To: Brandi Flyr, Nebraska Department of Natural Resources	
From: Larry Land, P.E. and Tricia Sebes, P.E.	Project:
CC: John Engel, P.E., Marc Groff	
Date: November 1, 2013	Job No:

RE: Review of Central Nebraska Groundwater Flow Model

Hydraulic Conductivity

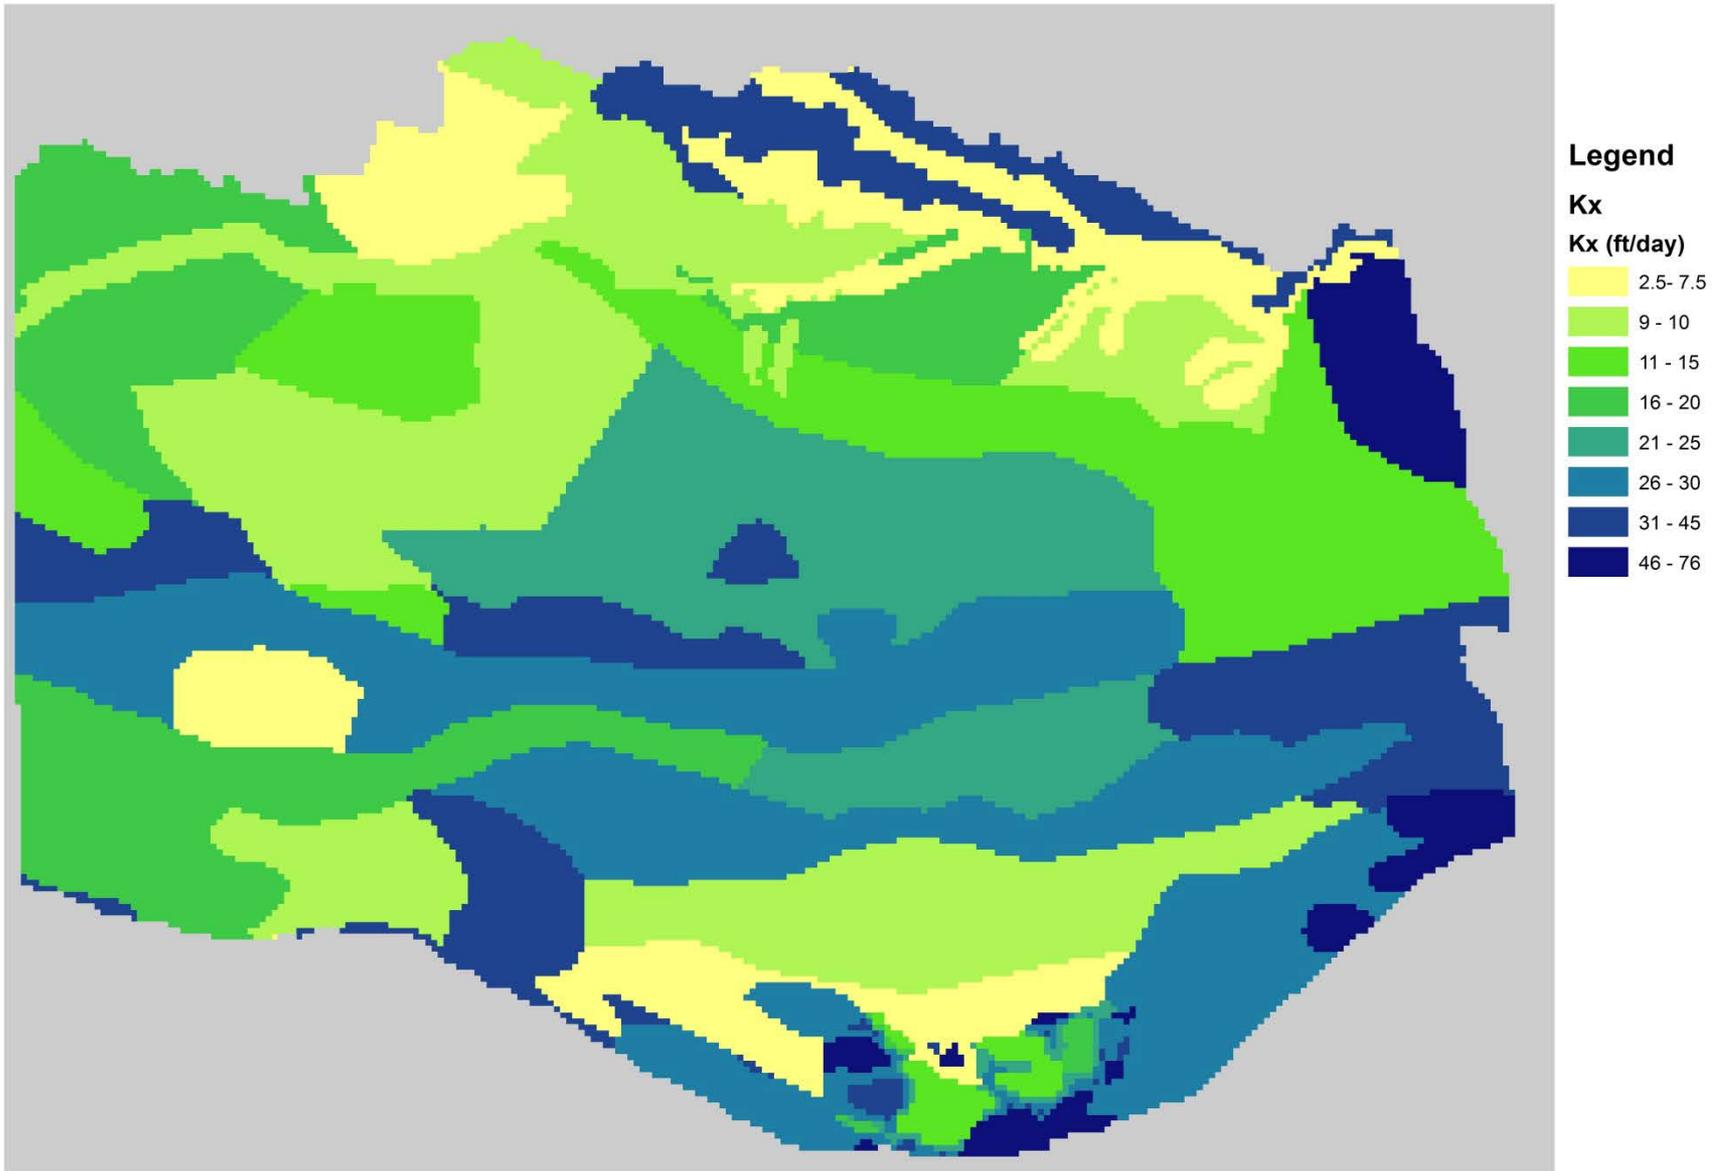
Sect 5.7, Fig 5-2: There are several substantial breaks in the hydraulic conductive ranges, i.e., where a transition from one zone to another jumps over one or more intermediate zones. The worst (or best example) is the 2.5-7.5 zone within a 25-30 zone (southwest area). On the surface this suggests an “Over Calibration” or not enough zones within the model. This is more cosmetic than a flaw. Bottom line, I do not suggest adding more zones within the model for the transition, which may require some recalibration. This is just a suggestion for future model development.

Transmissivity

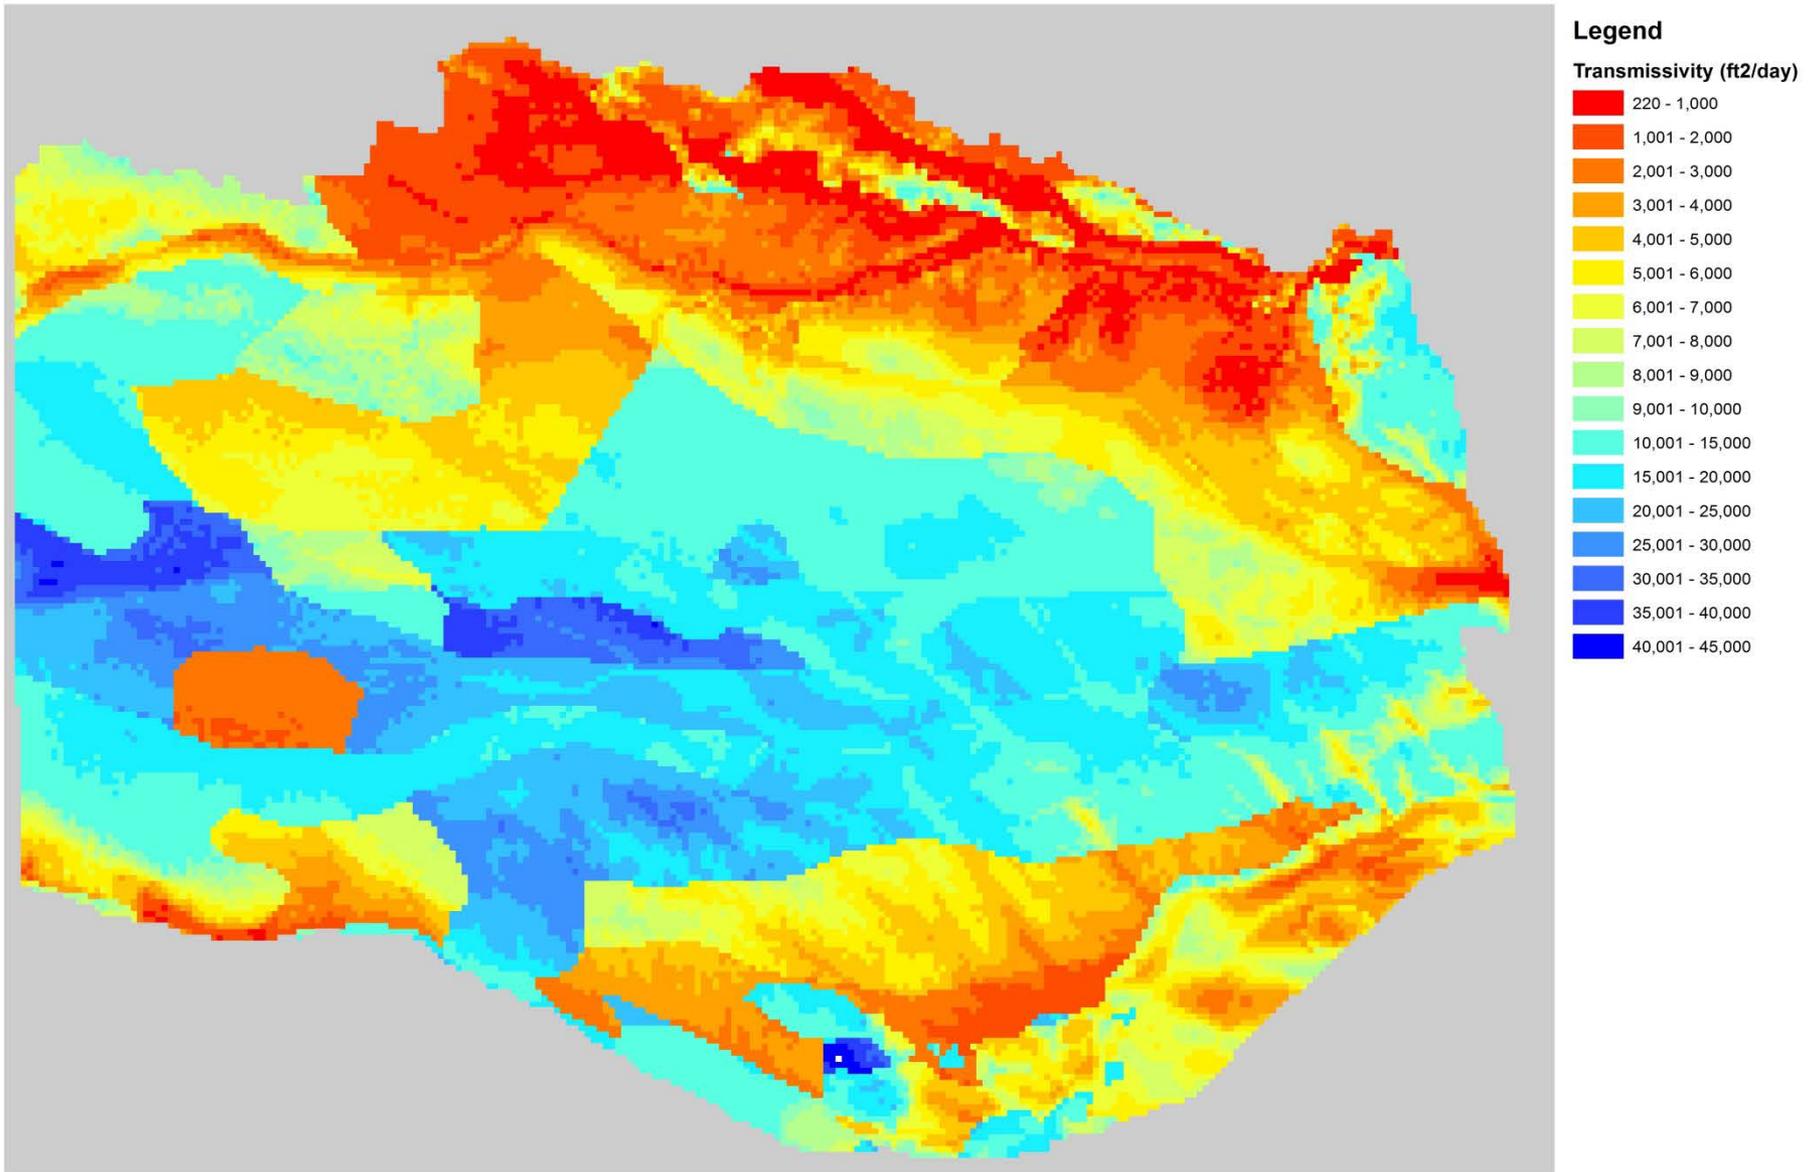
The only unusual distribution of parameters was Transmissivity where some relatively low T values were next to some relatively high T values.

Evapotranspiration Rate

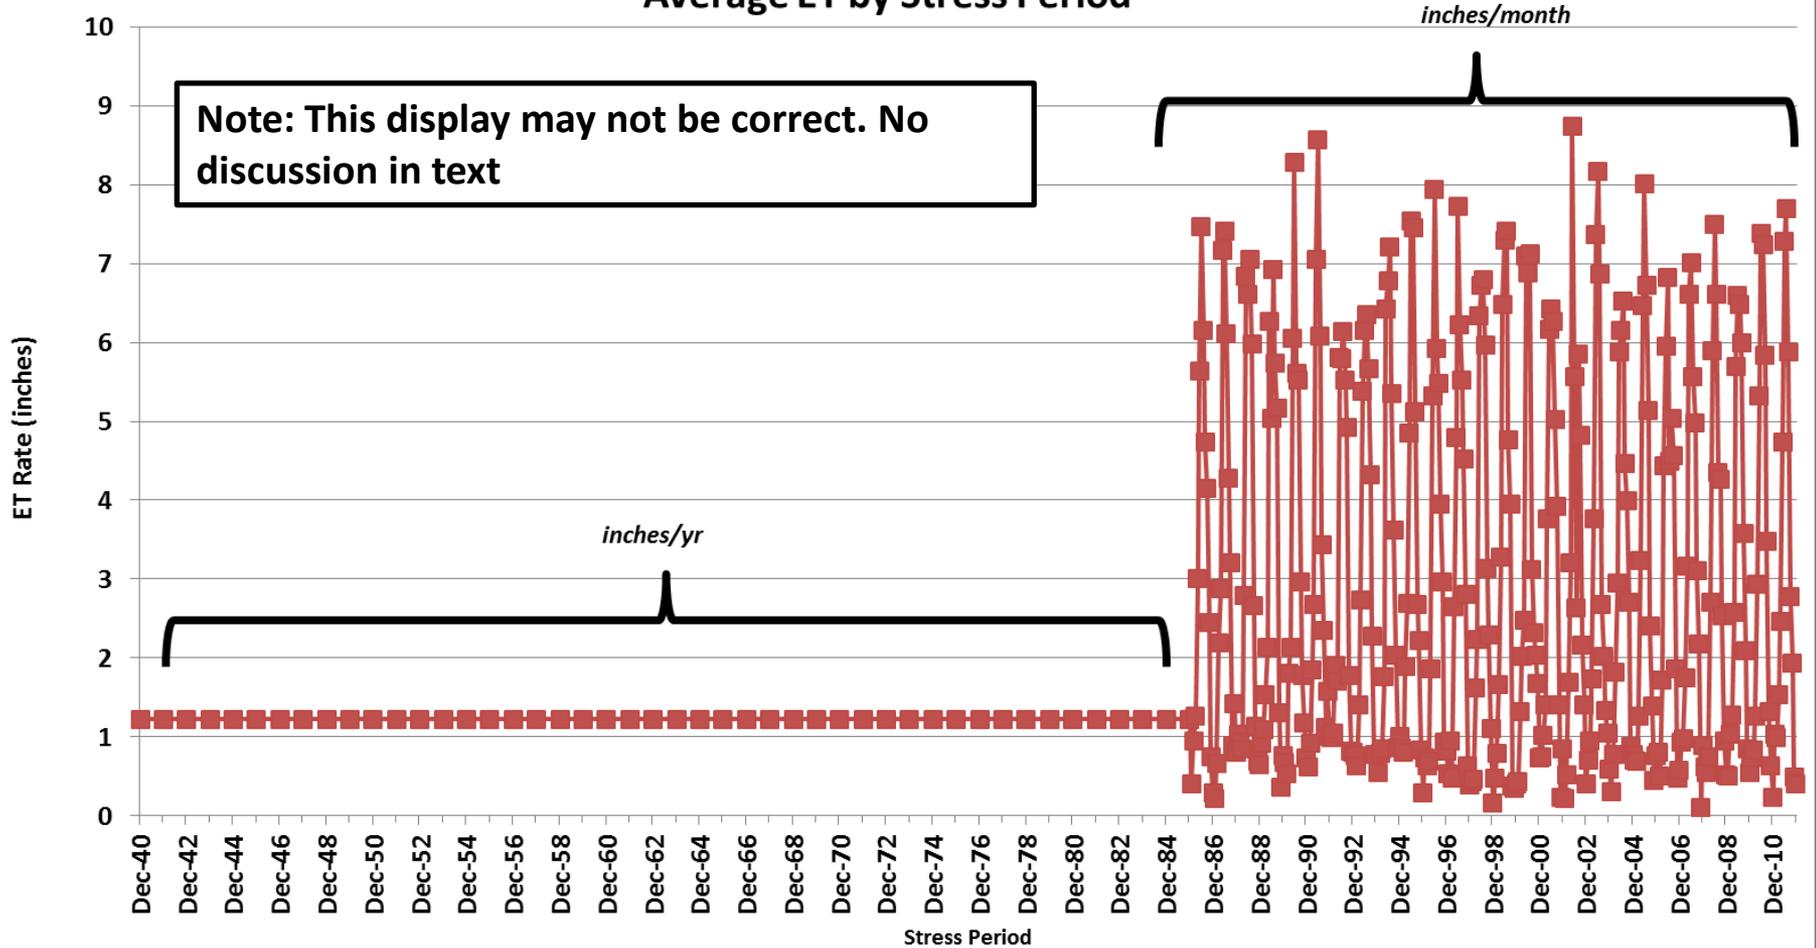
Sect 5.8: The model data set shows a monthly distribution of ET rates, but this monthly signal is not discussed in the text.

Sect 5.8, Fig 5-4: Are the evapotranspiration rates potential or actual? What date or timeframe does this ET rate correspond to?
